Maricopa Multi-Generational Center & Aquatics Facility City of Maricopa

Basis of GMP October 10, 2012

The Basis of GMP is a written explanation clarifying the scope, assumptions and exclusions used in establishing the Guaranteed Maximum Price dated 10/10/2012.

040 - EIFS

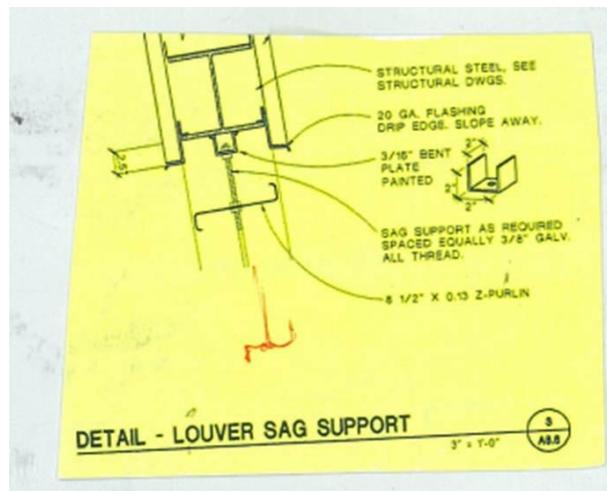
1. We have assumed that the EIFS at the soffits will be direct applied over exterior densglass without the foam. The detail shows foam, but we have not included foam, as the Fire Marshall typically will asked for it to be removed at soffits.

049 - SHADE LOUVERS

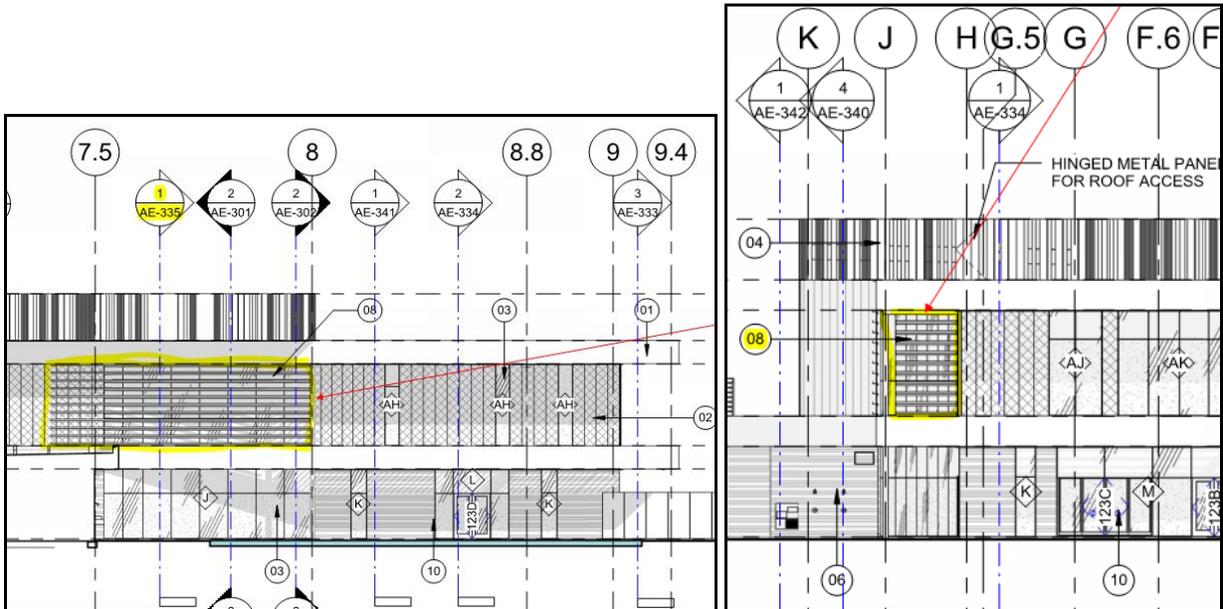
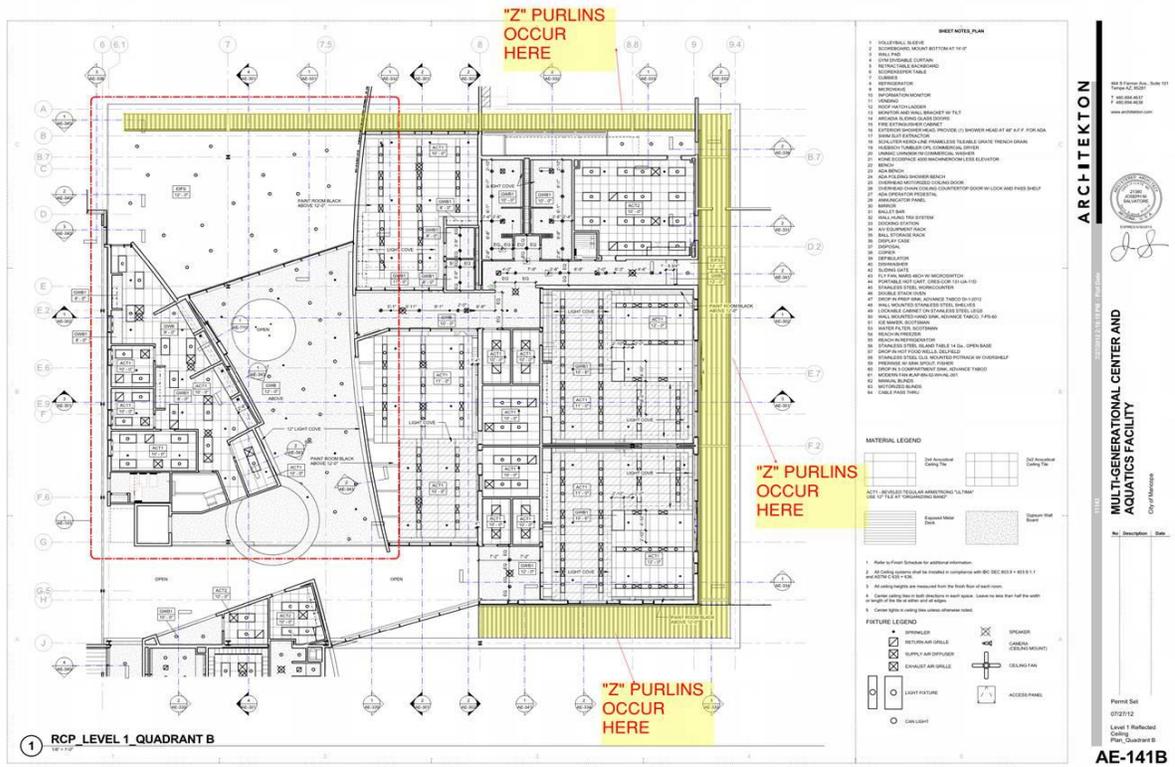
1. We have included 'Z' purlin shade lovers with sag support per the following detail, and in the locations shown below:
